Subject: Byron Station Units 1 and 2
Braidwood Station Units 1 and 2
Battery Area Woven Wire Fences
NRC Docket Nos. 50-454/455 and
50-456/457

Inspection Report Nos. 50-456/83-17; 50-457 (83-16)

Item 3 - Inspection of Safety-Related 125 Volt DC Battery
Areas for Unit 1 and 2

Figure b-1: Miscellaneous Electric Equipment Room
(and Battery Area) Ventilation System
(Typical)

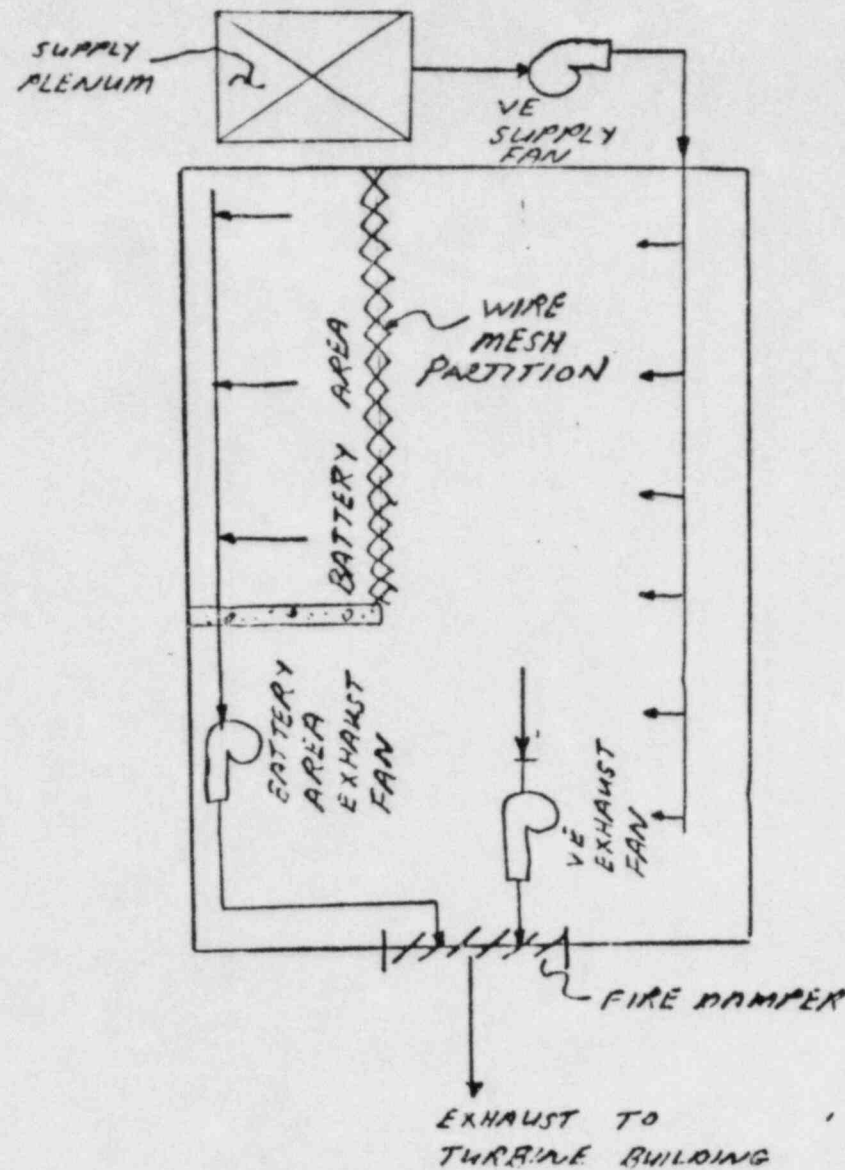
"The 'as built' condition of the 125 volt dc safety-related battery banks at Byron and Braidwood are not enclosed by a battery room with three hour fire rated wall as recommended by Appendix A of Branch Technical Position 9.5-1 paragraph C.7.8. The battery alcove which now has become a part of the electrical equipment and switchgear room may permit hydrogen and other gases liberated from the battery cells to free flow in undetermined directions. Air and gas movement in the battery alcove is dependent upon the operation of the designed battery room and electrical and switchgear room exhaust systems; however, these systems do not have a positive suction on the total battery area, or all cells. Further, the ventilation system as designed for the battery alcove drops three and one half feet below the ceiling thus leaving

a dead air space for the possible accumulation of hydrogen gas. The adjacent electrical equipment and switchgear rooms have ceiling areas with as much as eight foot of dead air space and are not equipped with explosive-proof electrical circuits and/or explosion-proof electrical motors for the exhaust fans. These fans are now part of the ventilation system committed to remove hydrogen gas.

The primary concern, as described in this section of the report, relates to the adequacy of the design of the battery area ventilation system; i.e., the ability of the ventilation system to prevent the accumulation of hydrogen gas in the battery area, and in the adjacent Miscellaneous Electric Equipment Room, in sufficient quantities to create a potentially explosive mixture. The following discussion is intended to resolve that concern.

Figure b-1 illustrates the equipment arrangement and air flow for the Miscellaneous Electric Equipment Room ventilation system. As previously noted, the safety-related 125V DC Battery Area is a part of the Miscellaneous Electric Equipment Room, which is enclosed by a three-hour fire-rated barrier. The battery area exhaust ventilation system will remove 475 CFM from the battery area. Based on the volume of the battery area, and on the calculated maximum hydrogen evolution rate (which could occur with a failure of the battery charging system), the ventilation system will limit the hydrogen concentration in the battery area to 1.44%; 2% less than the "2% of the total volume of the battery area" allowed by IEEE Std. 484-1981 (which itself is conservative). All of the make-up air for the battery area exhaust is drawn

from the Miscellaneous Electric Equipment Room. In order to purge (i.e., sweep) the total volume of the battery area, the exhaust duct is located adjacent to the wall opposite the wire mesh partition. The exhaust ductwork is located at the highest practical point in the room (i.e., immediately under the intermediate roof structural steel) and extends over the entire length of the rear battery rack.

Even if it is assumed that a fraction of the hydrogen gas (say 30%) escapes to the Miscellaneous Electric Equipment Room, the maximum concentration of hydrogen in this room is 0.022%, which is insignificant in comparison to the maximum allowable design concentration of 2%.

Since this ventilation system will limit the hydrogen concentration in the battery area to less than 2%, "the battery area (per IEEE Std. 484-1981) . . . should be considered non-hazardous, thus special electrical equipment enclosures to prevent fire or explosions should not be necessary." However, to provide additional conservatism, spark-proof fans with explosion-proof motors are provided for the Battery Area Exhaust Fans (1/2VE02C and 1/2VE03C).

AUXILIARY BUILDING MAIN FLOOR PLAN EL. 45'-0"

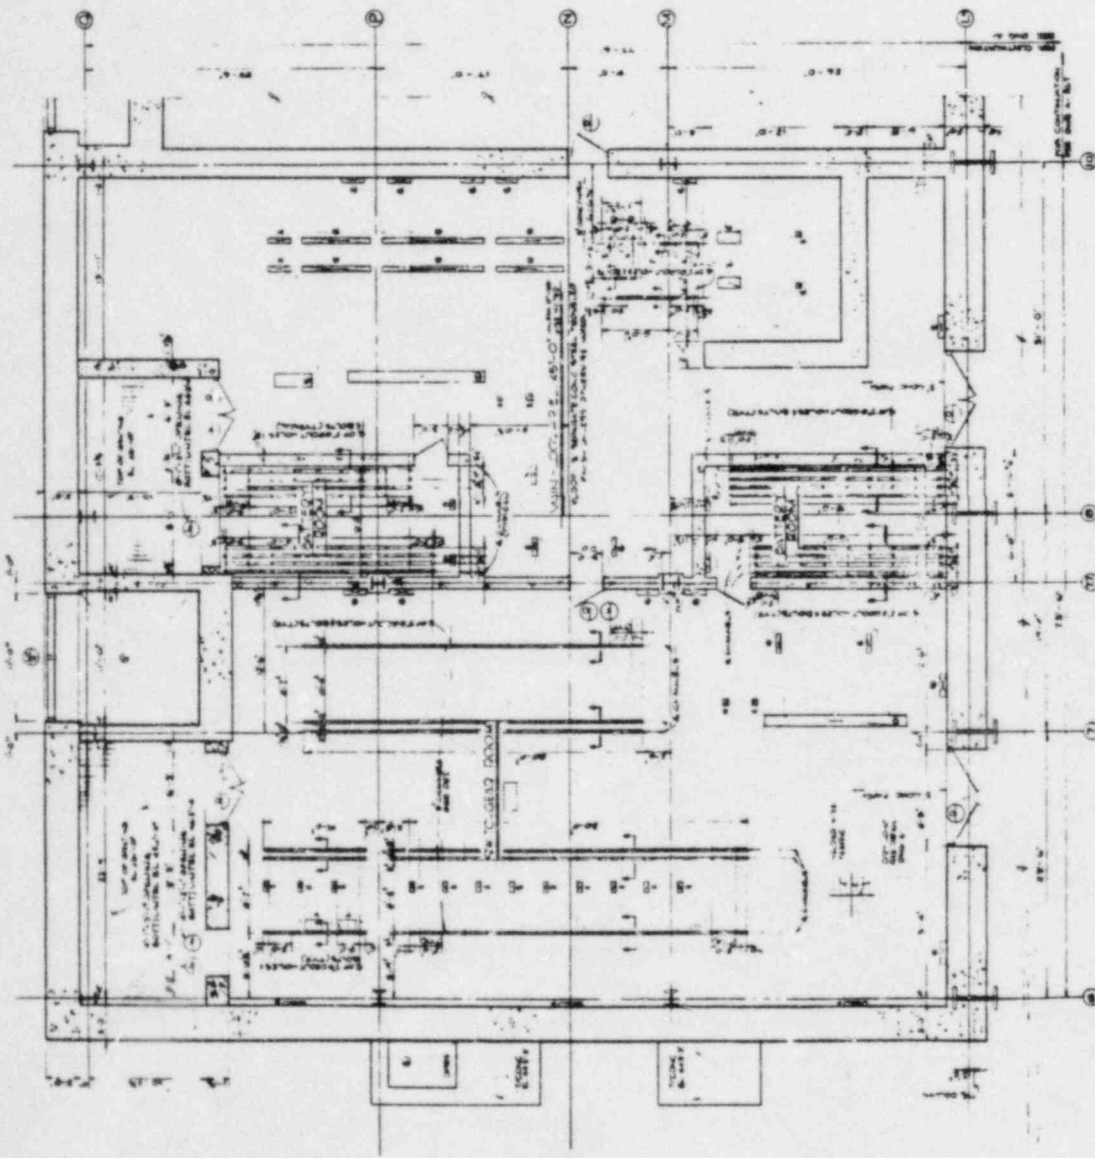
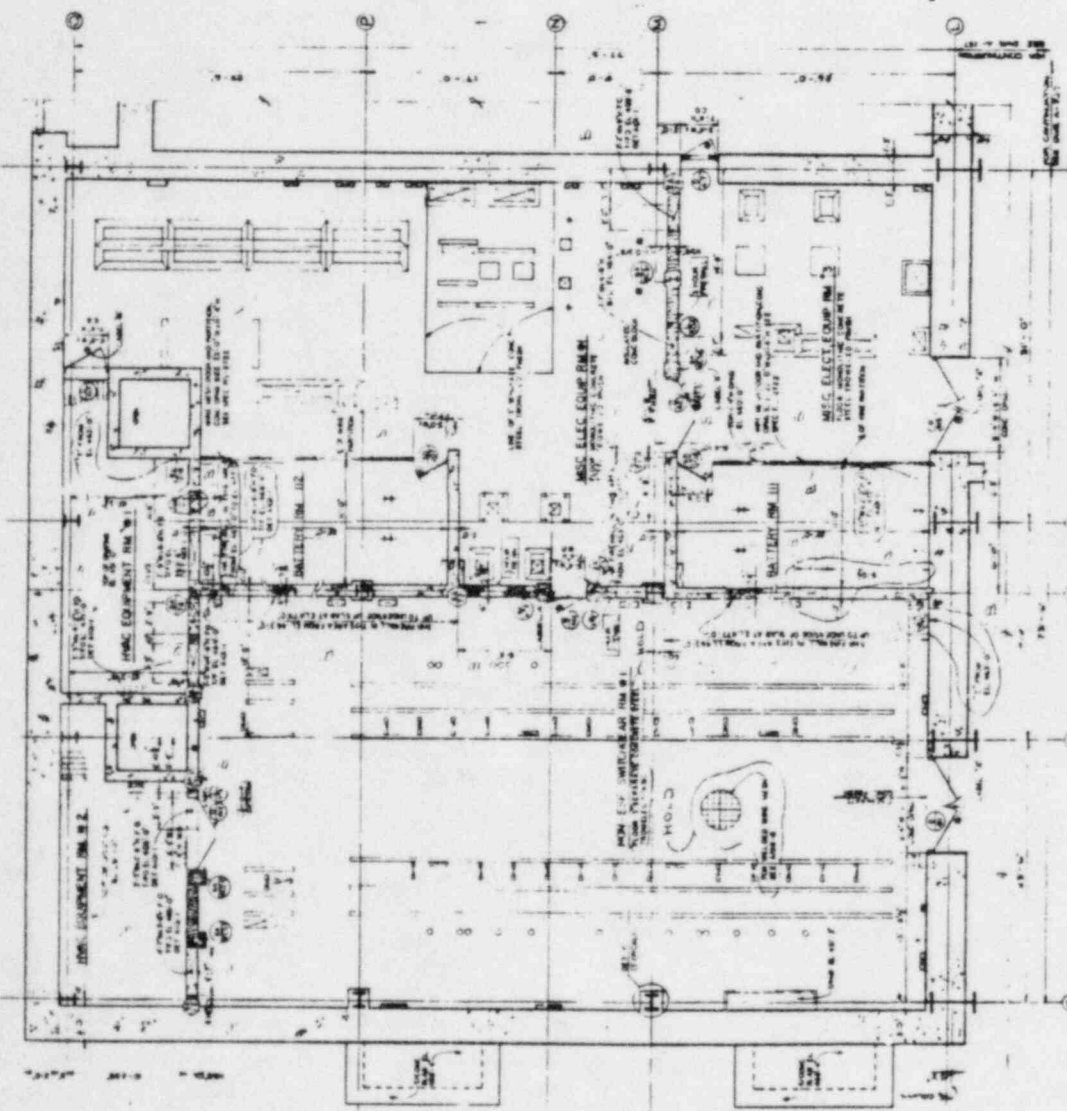
"The auxiliary building floor plan, elevation 451, as shown on drawing A-266, dated August 1974, included a battery room (an interior space enclosed by walls and separated from other similar spaces by walls) with Category I three hour fire rated floor, ceiling and walls. As designed, these safety-related battery rooms included a ventilation system for an air supply and an exhaust system to remove hydrogen gases liberated by the battery cells. The concrete floors, walls and ceiling supporting the designed 111 and 112 battery rooms, 451 foot elevation, were poured during a four month period from March 21, 1978, through July 11, 1978, at Braidwood and essentially during the same time frame one year earlier at Byron. On March 24, 1978, Revision B to drawing A-266 was completed. This revision removed one twenty-two foot concrete Category I block wall from each safety-related battery room and replaced it with an expanded metal wire mesh fence.

- (1) Drawing A-266, dated August 7, 1974, (referenced by the inspector) copy attached, did show a concrete block wall on the south side of Batteries 111 and 112 (the wall in question); however, it should be noted that this issue of this drawing was a preliminary, unsigned drawing showing one (of several) alternate conceptual designs (being considered at the time) which was issued only for "Ref. for bids Spec. F/L-2722" (i.e., this issue of this drawing was utilized only to hire a concrete contractor for the project). Drawing A-266 was not signed (approved) nor released

for construction until Rev. B, dated March 24, 1978 (copy attached). This issue (Rev. B), and all subsequent issues, of this drawing shows a "wire mesh door and partition" on the south side of Batteries 111 and 112.

(2) Contrary to the report, which states that "This revision removed one twenty-two foot concrete Category I block wall from each safety-related battery room and replaced it with an expanded metal wire mesh fence," the concrete block wall was not "removed" because it never existed on a drawing released for construction; i.e., the only approved design ever shown on A-266 was (and still is) a "wire mesh door and partition."
